ARMENIAN CHURCH AND CULTURAL CENTER JSP25-0031

Public Hearing at the request of Armenian Cultural Center of Greater Detroit, Inc. for approval of Special Land Use, Preliminary Site Plan, Phasing Plan, Wetland Permit, Woodland Use Permit, and Stormwater Management Plan. The subject property is located at 41100 Twelve Mile Road (Section 12). The applicant proposes phased construction of a church and accessory cultural center uses including a day care center.

REVIEW	RESULT	DATE	COMMENTS
Planning	Approval Recommended	06/30/26	• Special Land Use for place of worship in RA: Residential Acreage District • Special Land Use for daycare in RA: Residential Acreage District • Phasing Plan Approval • Zoning Board of Appeals (ZBA) variance required under Section 3.1.1.D and Section 4.10.5 for the monument height of 62.83 ft • ZBA variance required under Section 4.19.2F for the dumpsters to be located in the side yards • Items to be addressed at Final Site Plan submittal
Engineering	Approval Recommended	12/11/25	• Items to be addressed at Final Site Plan submittal
Landscape	Approval Not Recommended	06/12/26	• Landscape waiver under Section 5.5.3.A.v for deficiency in screening berms (supported

Figure 1. City of Novi Regulated Woodlands Map

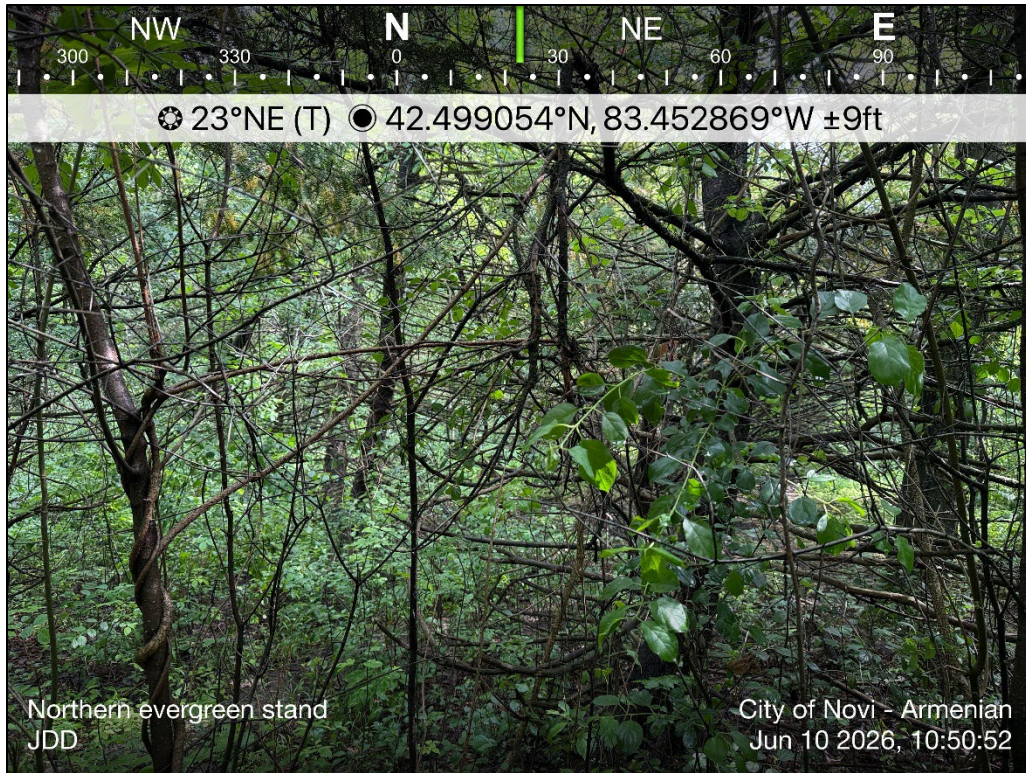
- b. An updated outline of regulated woodland areas is provided in **Figure 1**.
2. Pursuant to Chapter 37, Section 37-28, an accurate woodland survey should be provided and be accompanied by a separate key identifying the location of all trees eight inches at diameter at breast height (DBH) and greater, by size, common, genus and species names (i.e. Red Maple/*Acer rubrum*), and condition.

Figure 2. City of Novi Regulated Wetlands Map
Site Boundary is outlined in red
Approximate Wetlands are shown in Blue

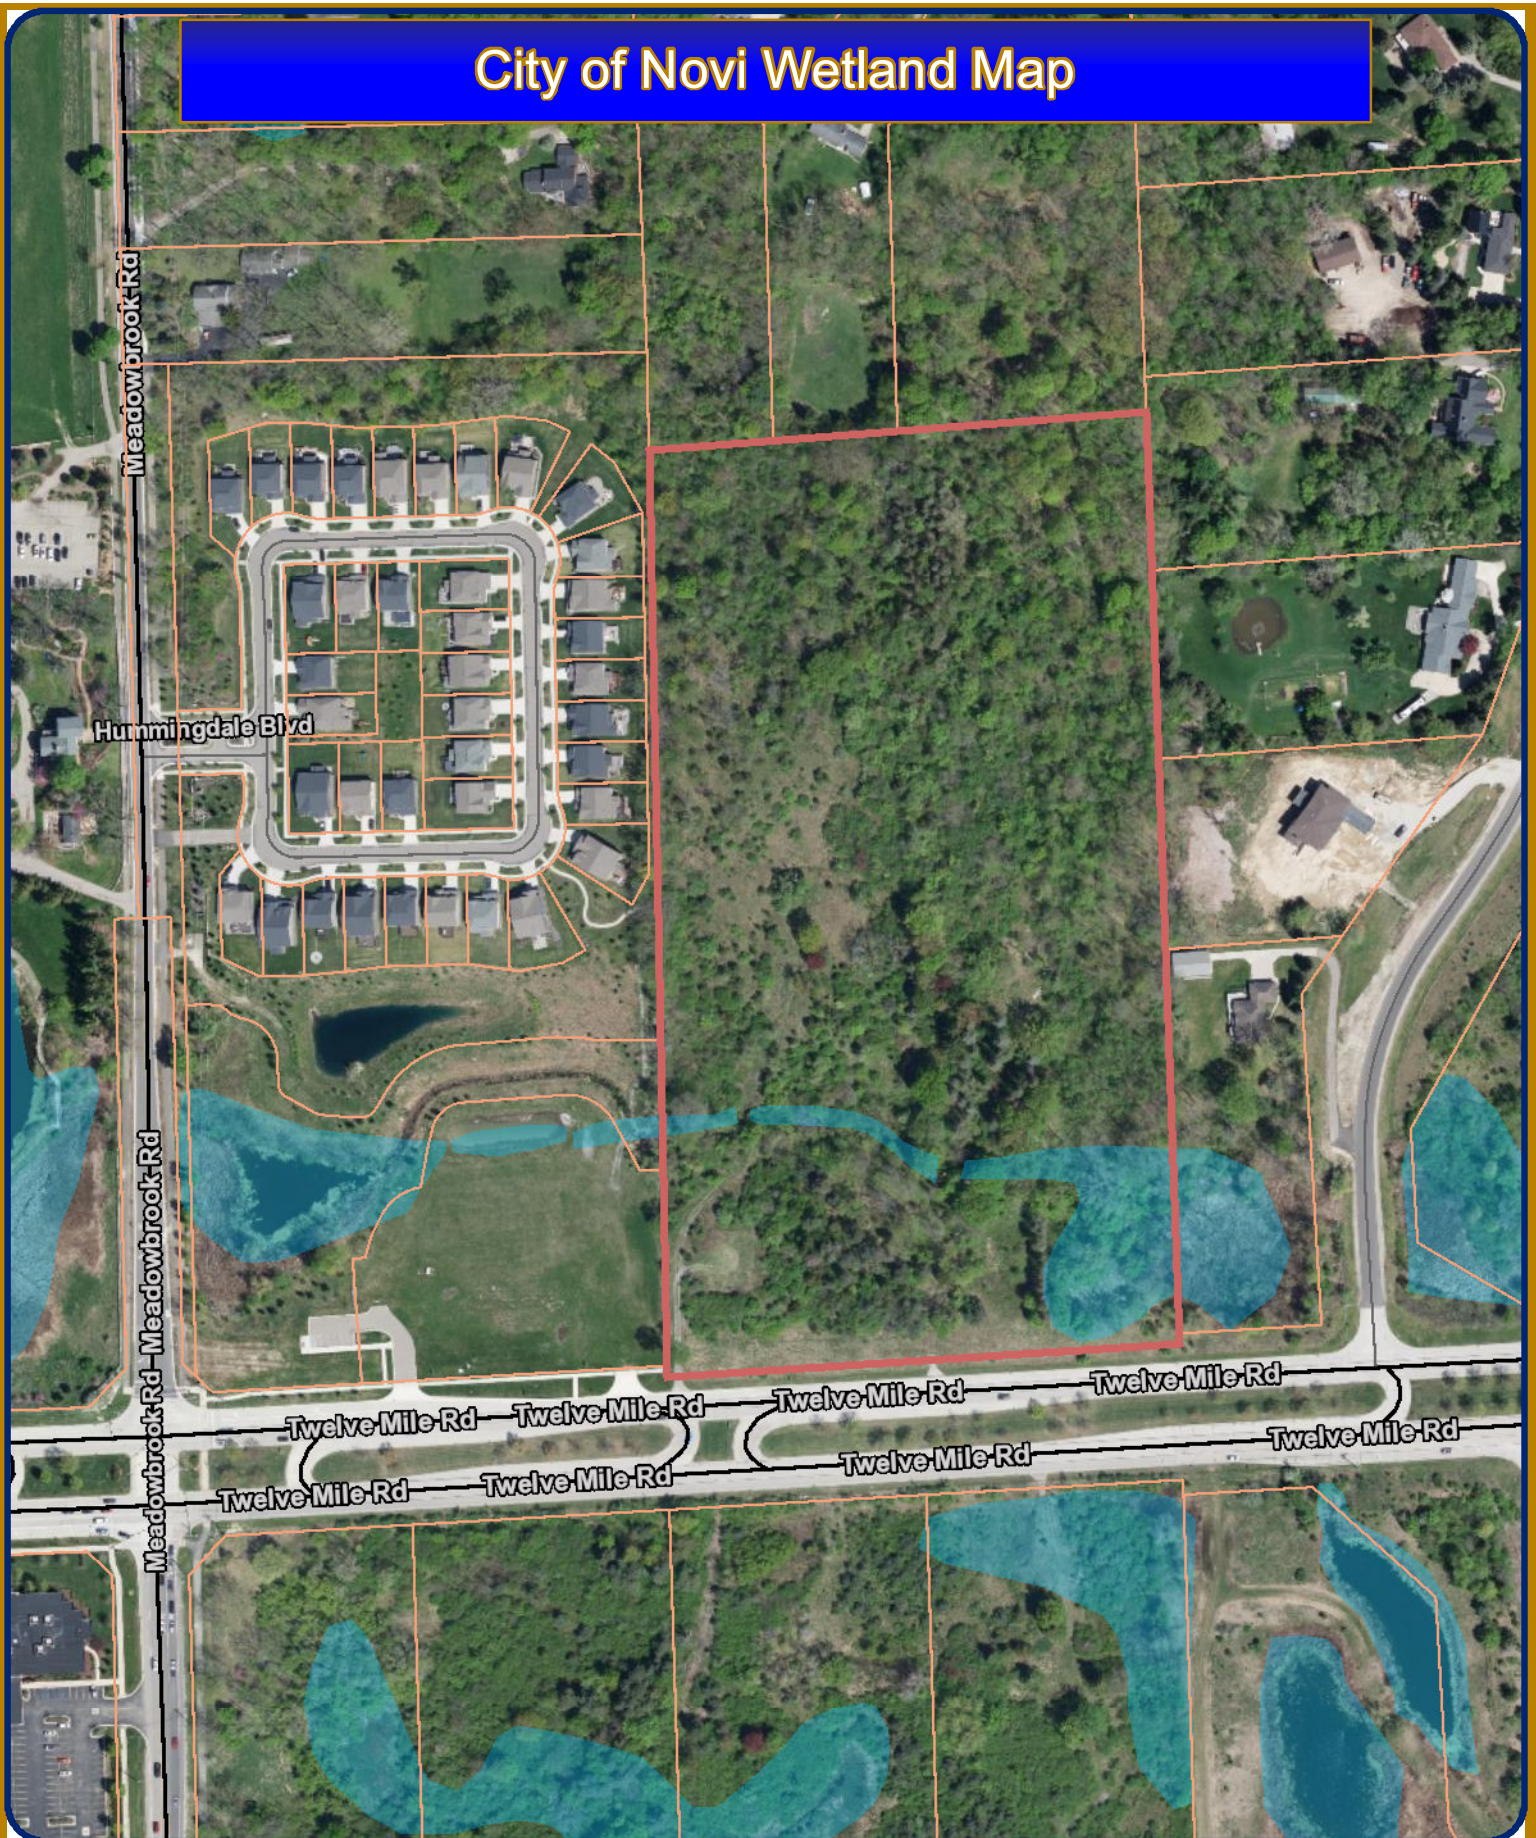
- ☒ City-regulated wetlands, as identified on the City of Novi interactive map website. Note that both wetland and property limits depicted on the City's map are considered approximations (**Figure 2**).
- ☒ Wetlands that are regulated by the Michigan Department of Environment, Great Lakes, and Energy (EGLE).
- ☒ Wetlands as identified on National Wetland Inventory (NWI) and Michigan Resource Inventory System (MIRIS) maps, as identified on the EGLE Wetlands Viewer interactive map website (provided in pre-app review). NWI and MIRIS wetlands are identified by the associated governmental bodies' interpretation of topographic data and aerial photographs.

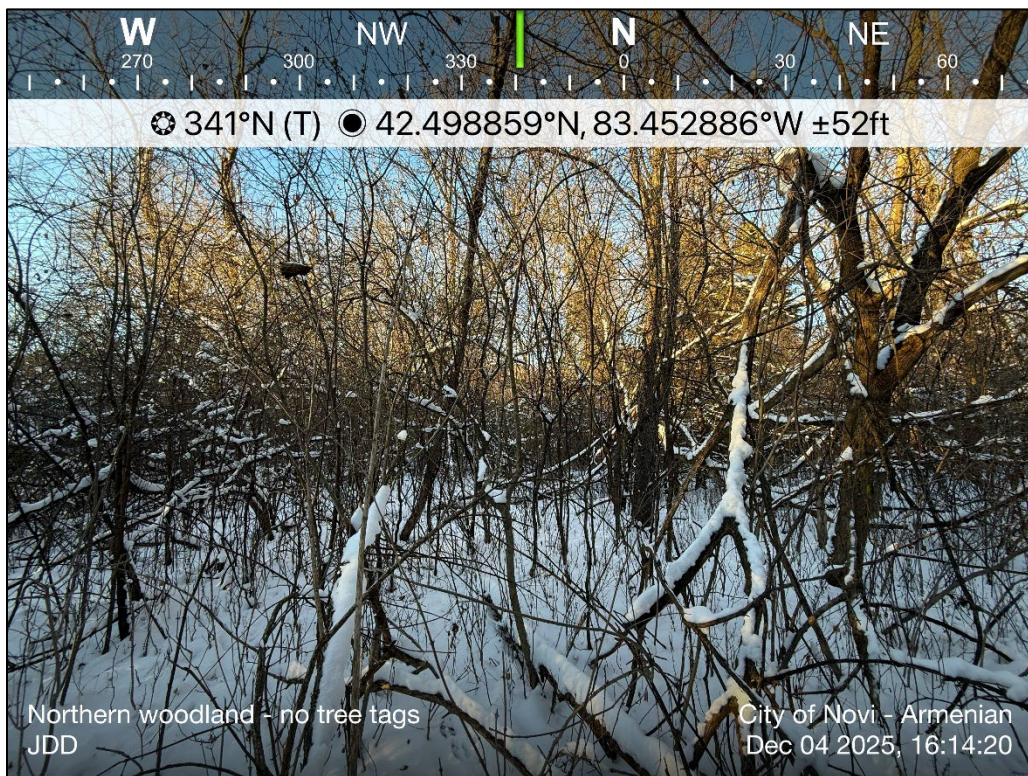
Some Norway spruce (*Picea abies*, foreground) trees on-site may have been misidentified as Colorado blue spruce trees (*Picea pungens*).

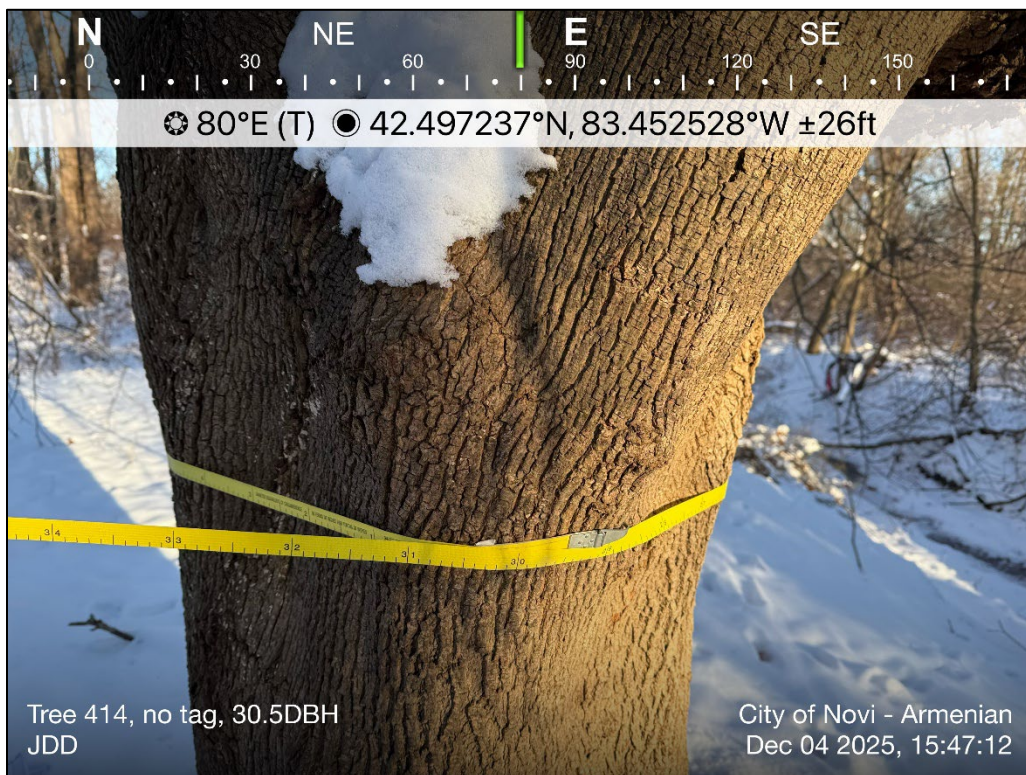
Likely Tree 389 (no identification present on-site), which was identified as having a DBH of 30-inches was measured to have a DBH of 40-inches on-site.

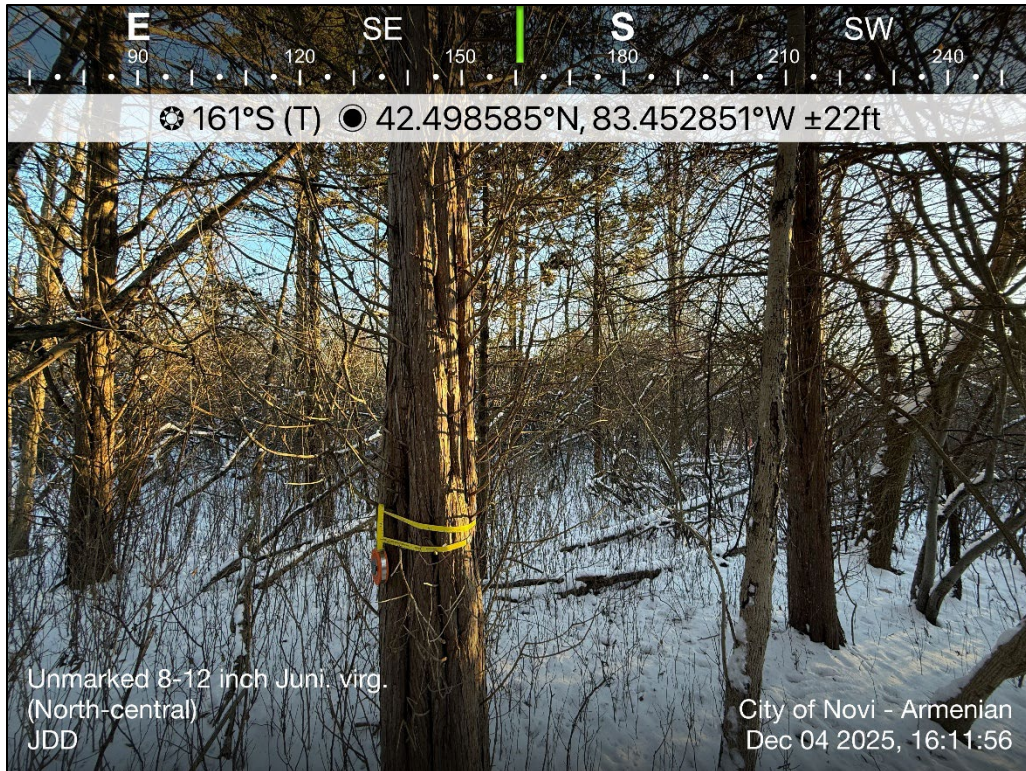
Likely Tree 414 (no identification present on-site), which was identified as having a DBH of 24-inches was measured to have a DBH of 30.5 (31)-inches on-site.
